Alert Service Bulletin

Bulletin No. 047

Turbocharger P/N 406610-0005 or -9005 & Turbocharger Center Housing P/N 409836-0005 Recall

Figure 1 - Turbocharger Center Housing
Date Code Location on P/N 409836-0005

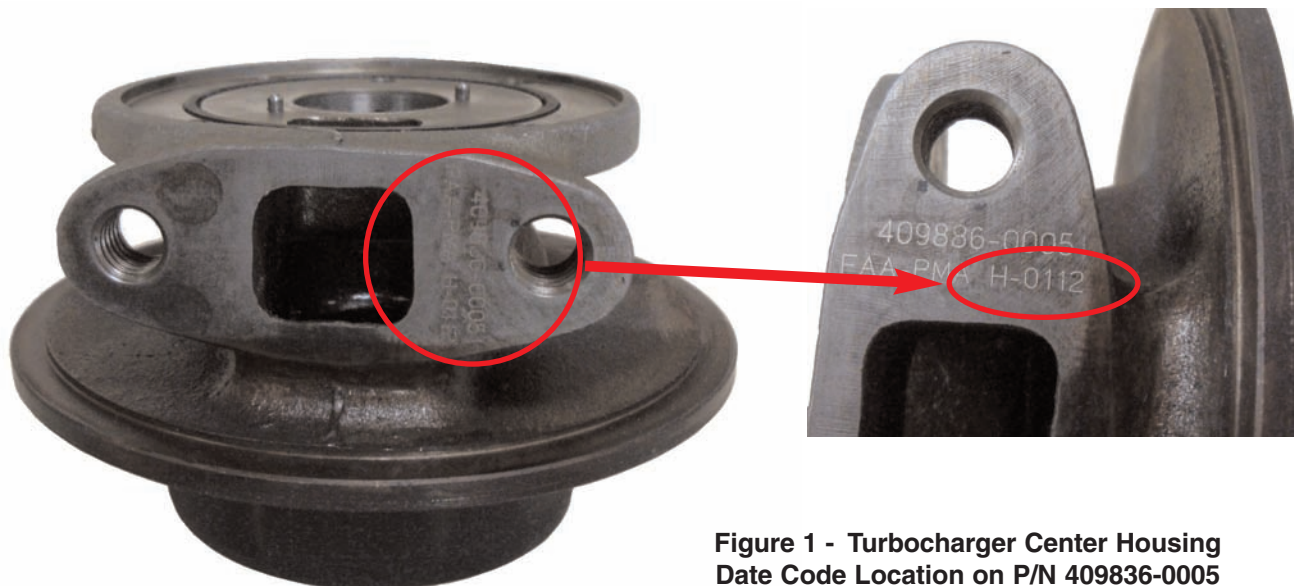
- (c) If the turbocharger was overhauled or repaired January 2012 or later, then determine the center housing date code by removing the oil drain fitting (see Fig. 1).

- (b) If a suspect turbocharger center housing is no longer in inventory and has been placed in service it will be necessary to locate the turbocharger and verify center housing date code by removing the oil drain fitting (see Fig. 1).

- (i) If date code H-0112 is found, continue with Corrective Action 2.
 - (ii) If a date code other than H-0112 is found reconnect the oil drain fitting per applicable aircraft and/or engine manufacturer's maintenance manuals or service instructions. Proceed to "Return to Service".

- (i) If date code H-0112 is found, continue with Corrective Action 2.
 - (ii) If a date code other than H-0112 is found reconnect the oil drain fitting per applicable aircraft and/or engine manufacturer's maintenance manuals or service instructions. Proceed to "Return to Service".
